**DETERMINATION OF NON-SIGNIFICANCE**

**City of Bellevue  
Development Services Department  
Land Use Division Staff Report**

**Proposal Name:** AT&T SB1750 West Bellevue Square  
**Proposal Address:** 9624 NE 8<sup>th</sup> Street

**File Number:** 14-136423-LA, Administrative Conditional Use

**East Elevation – Existing and Proposed**

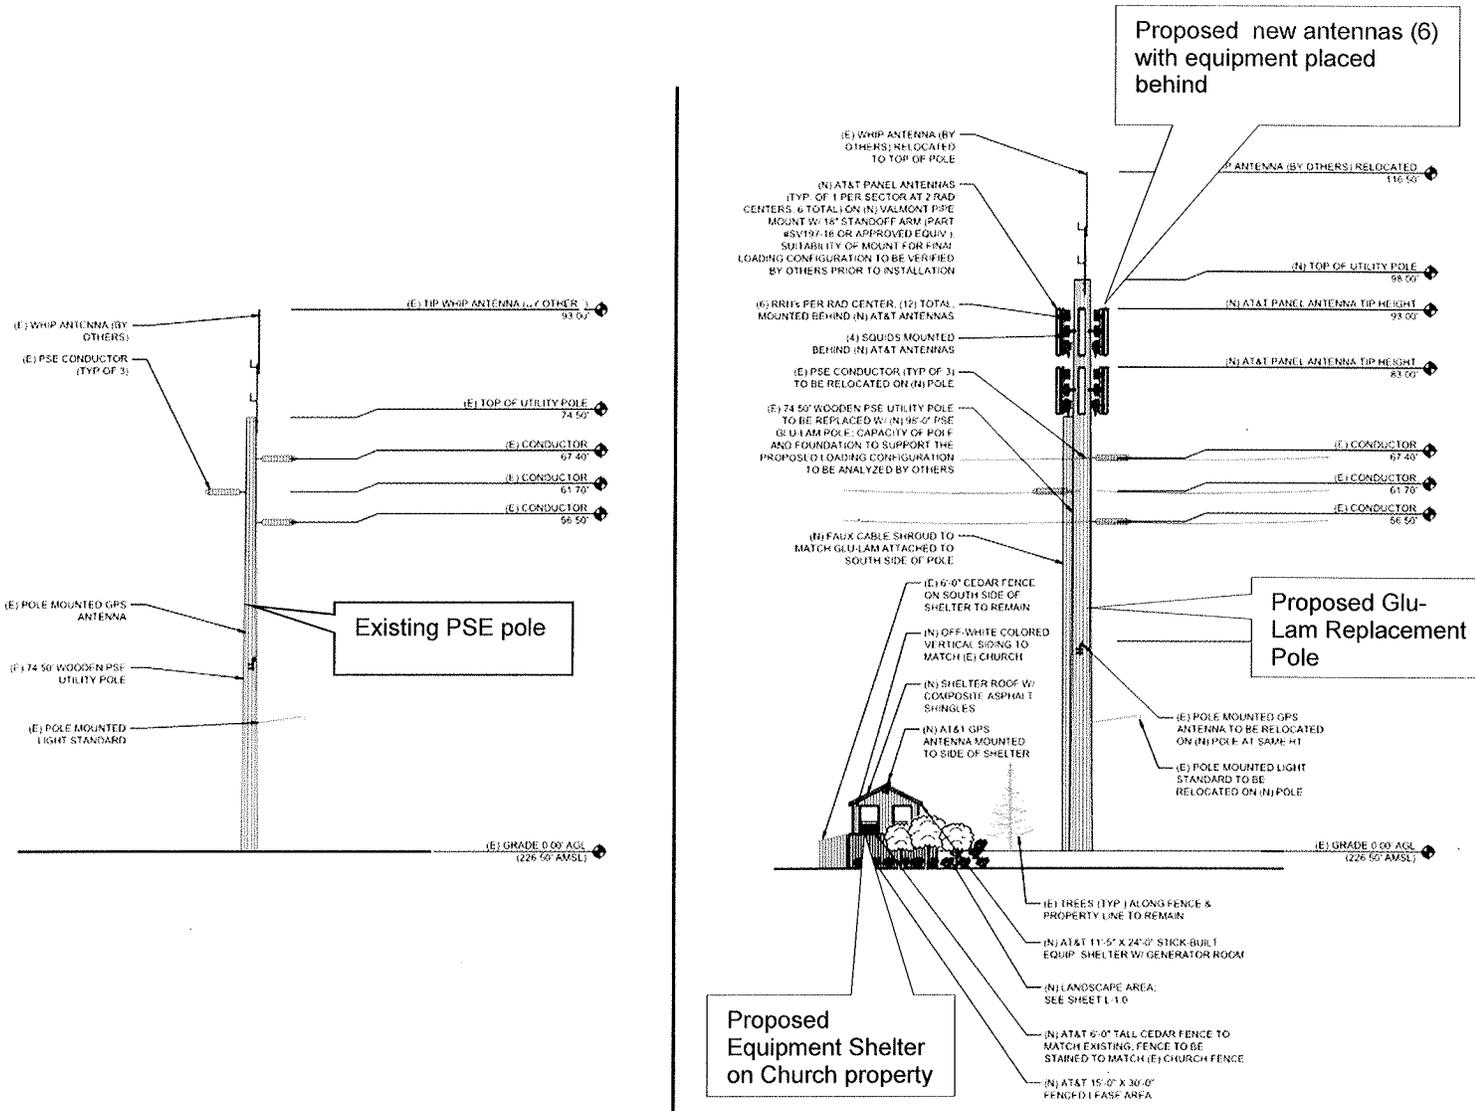
**C. Can the pole be camouflaged? Why can't the antennas be placed in a stealth configuration?**

**Response:** The Land Use Code (LUC) does not give Land Use the authority to require the applicant to use a tree camouflage pole. However, through application of the LUC, the applicant must meet certain development standards to help diminish the impact of this facility. This facility will be required to do the following:

- Construct a replacement glu-lam pole that will complement the surrounding mature trees and will have a residential character.
- Paint the antennas and all ancillary equipment to match the pole
- Contain the power cables and conduit within the support structure
- Pull any exposed cabling tight
- Screen the equipment on the ground by placing it in a structure that in turn will be screened by a wood fence and landscaping
- Retain and/or replace all existing landscaping at the base of the pole.

- The antennas mounts will be 18 inches, which is the shortest they can be while still allowing for both the correct angle of the antennas on the mount and the placement of RRH's and other RF equipment behind the antennas.

North Elevation of Equipment Shelter (facing NE 8<sup>th</sup> Street)

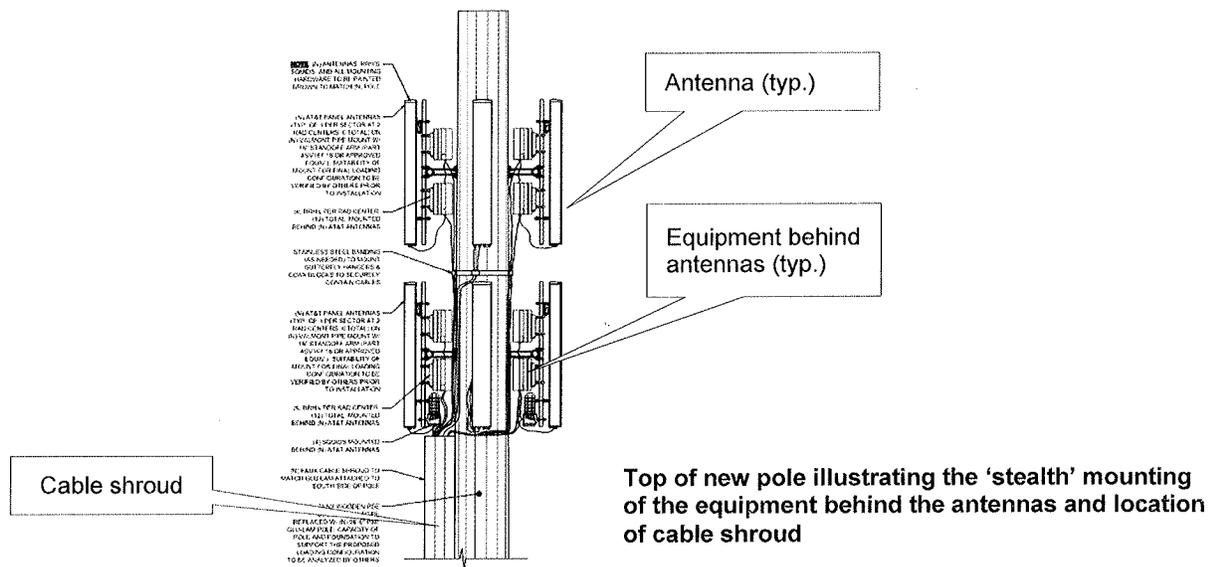
#### B. Will the shelter be visible from adjacent properties? How will noise impact the adjacent property?

**Response:** The equipment shelter will be screened with a wood fence and additional landscaping. It will be placed on a building pad that is approximately 10 feet lower than the street and through the use of color, materials, and landscaping, it will appear to be part of the Church campus.

Any associated noise will come primarily from the required HVAC units for the shelter. As a result of this review, the shelter has been redesigned so that the HVAC units will be placed along the eastern wall of the shelter - away from the neighboring properties. There is also an existing dense screen of evergreen trees between the Church and the neighboring properties to the west which will remain and further help to reduce any noise and/or visual impacts. Any noise from the facility will be required to meet the noise control requirements in BCC 9.18. **Refer to Condition of Approval regarding noise and construction hours in Section VIII of this report.**
